**Date of Issue:** June 2016

**Affected Publication:** API Specification 6A, *Specification for Wellhead and Christmas Tree Equipment*, Twentieth Edition, October 2010

## **ADDENDUM 4**

*Replace **Annex O** in its entirety with the following pages.*

Figure 3 c)

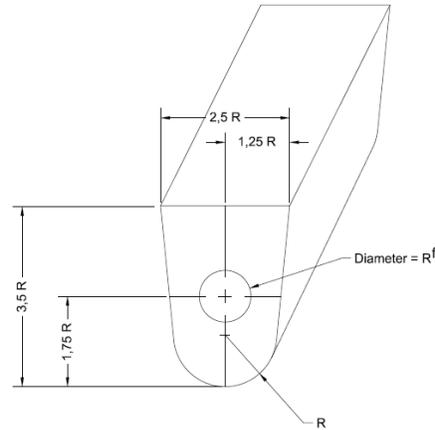
c) Keel block configuration, ER equals  $2,3R$

Figure 3, footnote f

Replace footnote f with:

“f

This area is the centre core  $1/4T$  envelope for test specimen removal.”

**Figure 6 — Hardness test locations for weld overlays**

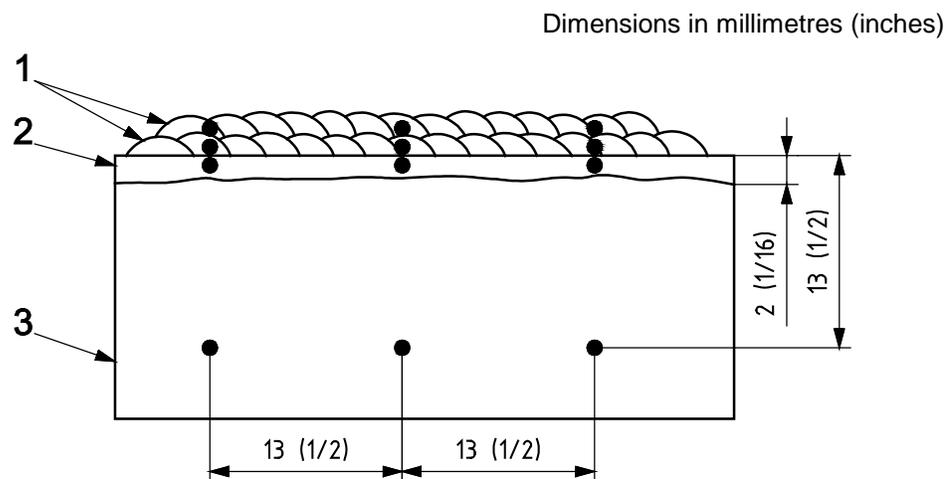
Welds for use in hydrogen sulfide service shall conform to the requirements of ISO 15156 (all parts) (NACE MR0175; see Clause 2). If the welding procedure is to be qualified for use on bodies, bonnets or flanges used for material classes DD, EE, FF or HH, hardness testing shall be carried out by the Rockwell method in accordance with ISO 6508 (all parts) or ASTM E18, or the Vickers 98 N method in accordance with ISO 6507 (all parts) or the Vickers 10 kgf method in accordance with ASTM E92. Hardness tests shall be performed at a minimum of three test locations in each of the base material, the heat-affected zone and in each layer of overlay up to a maximum of two layers. See Figure 6 for required hardness test locations.
